Access Compliance Report Public Rights-of-Way (Curb Ramps)

Main Street: IRVINE_BLVD		Cross Street: RED_HILL_AVE		Location:	S
ADA ID: RPAT211027090923	Ramp Type:Type 1 - Perpendicular Diagonal Initial Pass/Fail: Fail		Overall Compliance: No	Severity Score:	0

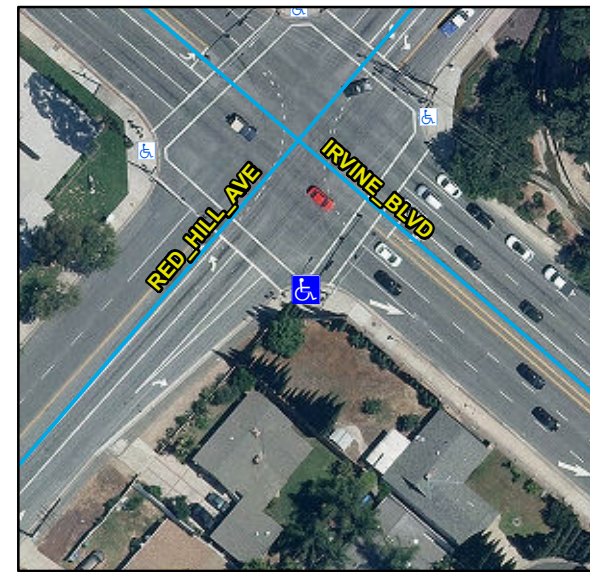
Compliance	Description	Data	Compliance	Description	Data
N/A	Ramp Length (in)	114	N/A	Flare Type LT	
Yes	Ramp Width (in)	48			N/A
Yes	Ramp Run Slope (%)	8.1	N/A	Flare Slope LT (%)	N/A
Yes	Ramp Cross Slope (%)	4.1	N/A	Flare Traversable LT	N/A
N/A	Landing Present	N/A	N/A	Flare Type RT	
N/A	Landing Length (in)	N/A			N/A
N/A	Landing Width (in)	N/A	N/A	Flare Slope RT (%)	N/A
N/A	Landing Run Slope (%)	N/A	N/A	Flare Traversable RT	N/A
N/A	Landing Cross Slope (%)	N/A	N/A	DWS Provided	N/A
N/A	Landing Movement Obstructed?	N/A	N/A	DWS Contrast	N/A
	Landing Movement Type	N/A	N/A	DWS Length (in)	N/A
N/A	Landing Shared	N/A	N/A	DWS Full Width	N/A
N/A	Clear Space	Yes	N/A	DWS Offset Left (in)	N/A
N/A	Clear Space To Crosswalk (in)	48	N/A	DWS Offset Right (in)	N/A
N/A	Marked Crosswalk 1	Yes	N/A	Marked Crosswalk 2	Yes
	Crossing 1 Direction	NE		Crossing 2 Direction	NW
	Marked Crosswalk 1 Width (in)	120		Marked Crosswalk 2 Width (in)	120

N/A	Ramp Inside Crosswalk 1	Yes	Yes	Ramp Inside Crosswalk 2	Yes
	Crossing 1 Slope (%)	7.9		Crossing 2 Slope (%)	3.4
	Crossing 1 Cross Slope (%)	1.9		Crossing 2 Cross Slope (%)	7.7
N/A	Gutter Ponding	N/A	Yes	Curb Slope	4.4
Yes	Gutter Lip Height (in)	0		Road Run Slope (%)	5.6
N/A	Gutter Run Slope (%)	N/A		Road Cross Slope (%)	9
N/A	Gutter Cross Slope (%)	N/A			
Yes	Overall Surface Condition: Acceptable		No	Perp Joint Present	No
	Cross Gutter Present?	No		Spandrel Present?	No
	Replace Cross Gutter?	N/A		Replace Spandrel?	N/A

Remove & Replace Curb Ramp With Two New Directional Ramps or Equivalent.

R204.3, STD 1115
